ADDENDUM #1

Reference: New Clearfield Maintenance Facility
Utah Department of Transportation – Clearfield, Utah
DFCM Project No. 06034900

ADDENDUM NO. 1 to the Contract Documents for the Construction of UDOT Maintenance Station #1424, Clearfield, Utah.

B2 | ACCESSIBLE TOILET DETAIL

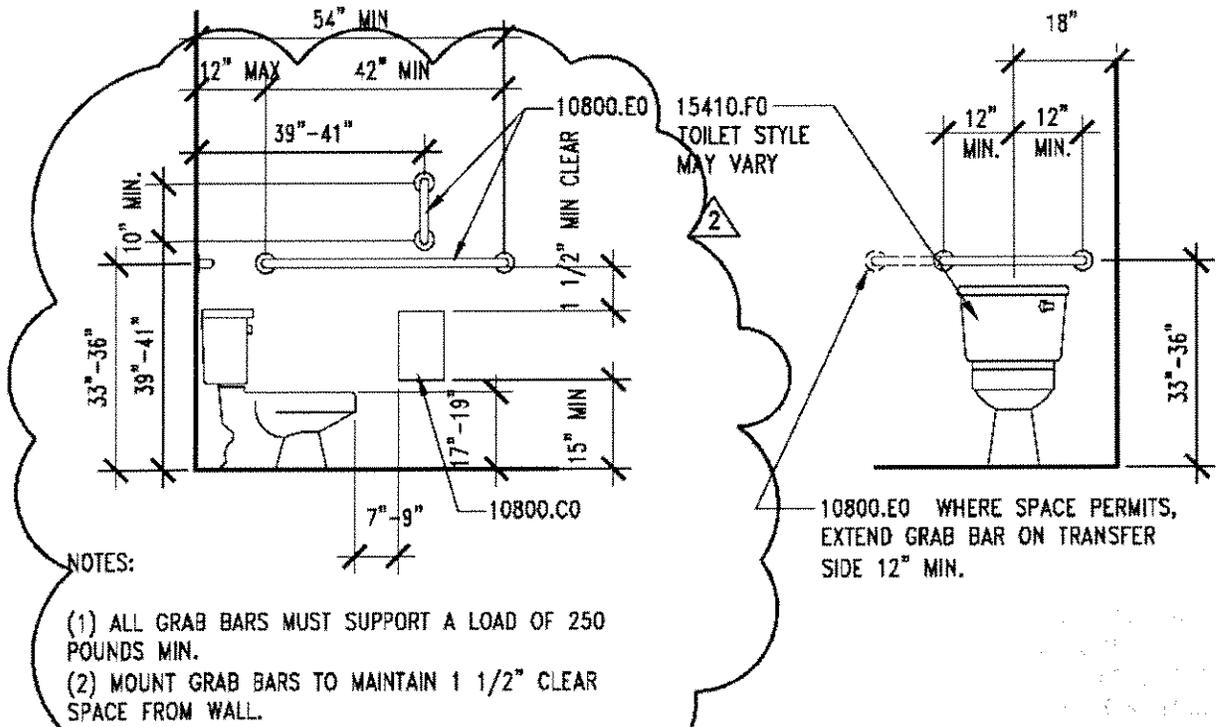
- a. Delete Specification #03055 in its entirety.
- b. **Sheet G000** – Add note "CONSTRUCTION OF NEW STATE BUILDINGS AND REMODELING OF EXISTING BUILDINGS SHALL COMPLY WITH ALL THE REQUIREMENTS OF THE DFCM STANDARDS, INCLUDING ENHANCED ACCESSIBILITY. THE DFCM STANDARDS CAN BE FOUND AT THE FOLLOWING WEB SITE: www.dfcu.utah.gov.
- c. **Sheet AE401** – Revise Detail B2/AE401 to include notes and vertical grab bar. See attached sheet 1.1.
- d. **Sheet AE501** – Add General Note #4: CONTRACTOR TO ENSURE THAT THE METAL BUILDING MANUFACTURER PROVIDES STRUCTURAL GIRTS IN SUFFICIENT QUANTITY TO SUPPORT INTERIOR FINISHES.
- e. **Sheet AE502** – Revise Keynote Legend to include Keynote: "09678.E1 – RUBBER BASE"
